Report to the Future Melbourne (Planning) Committee

**Ministerial Planning Referral: TPM-2019-6
645-681 Elizabeth Street, Melbourne**

3 September 2019

DELEGATE REPORT MINISTERIAL PLANNING REFERRAL

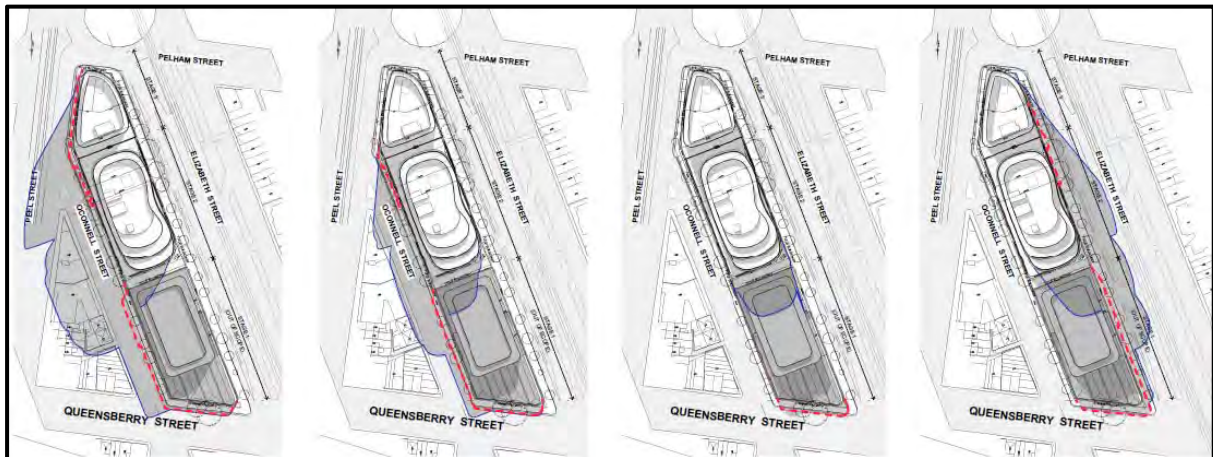
Assessment: Does not comply

The proposed development seeks to create a ~7.7 metre wide publicly accessible private laneway along the boundary shared with 'Stage 1'.

The plans referred to in Planning Permit PA1800432 identify that the development for the neighbouring 'Stage 1' site achieves setbacks to the lane of between 3 metres (levels 4 and above) and 5.35 metres at level 3 (resulting in a setback from the opposite side of the lane of 9 – 11.35

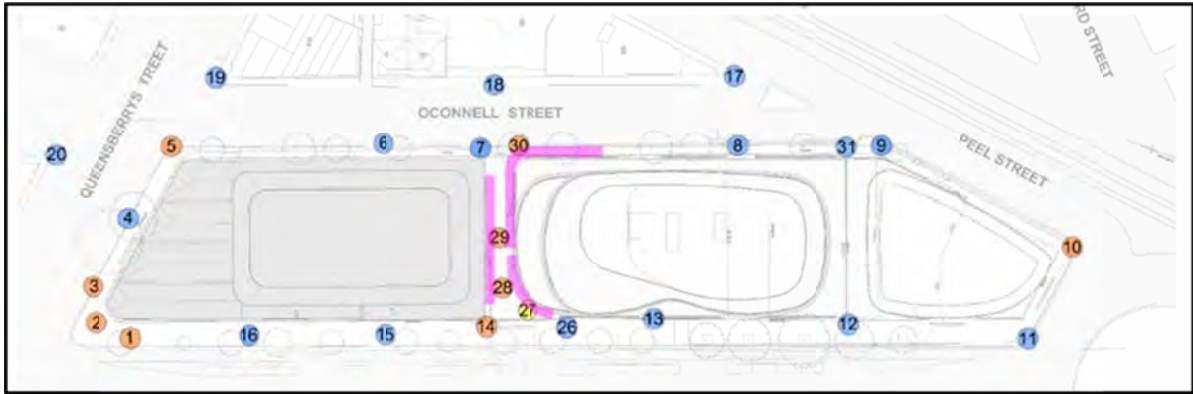
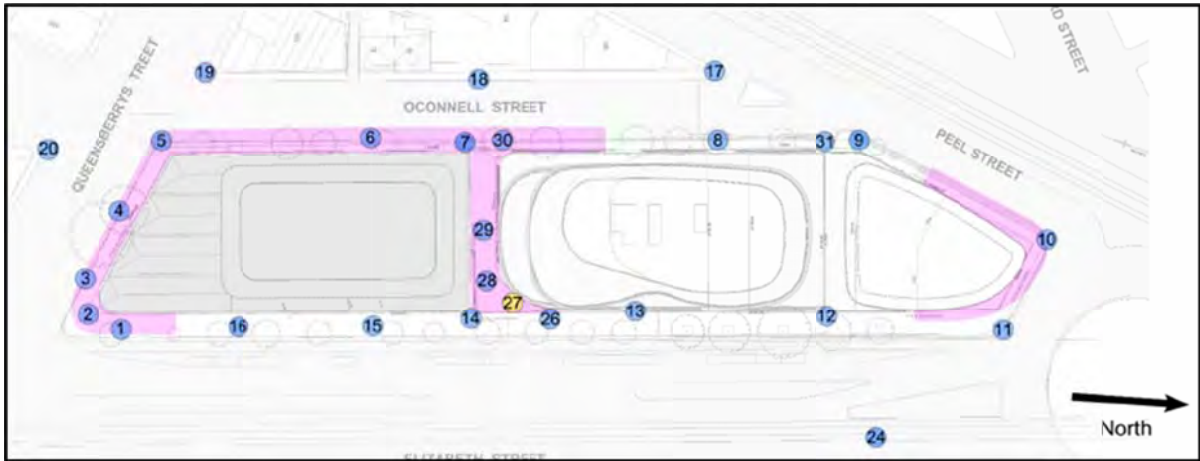
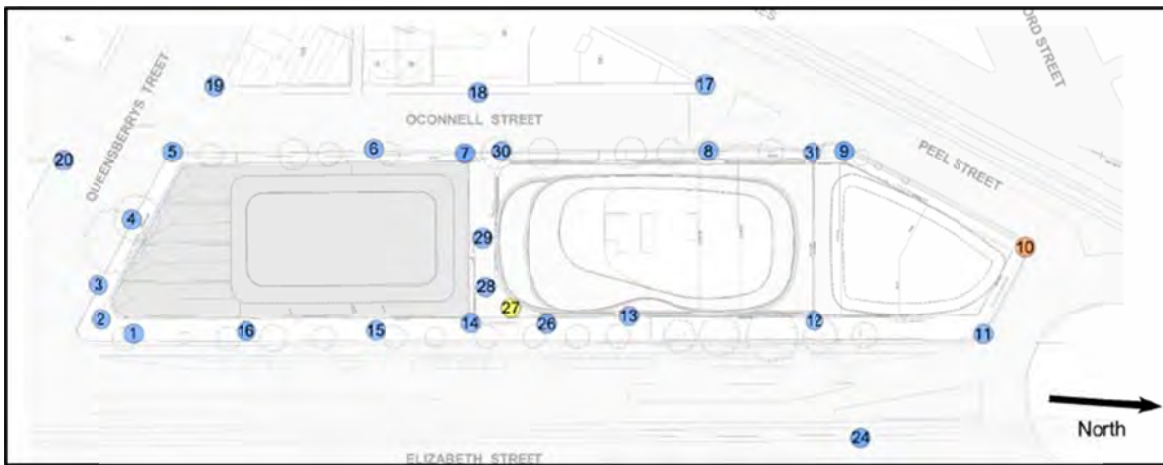
The proposed development therefore does not comply with the Weather Protection requirements of DDO61.
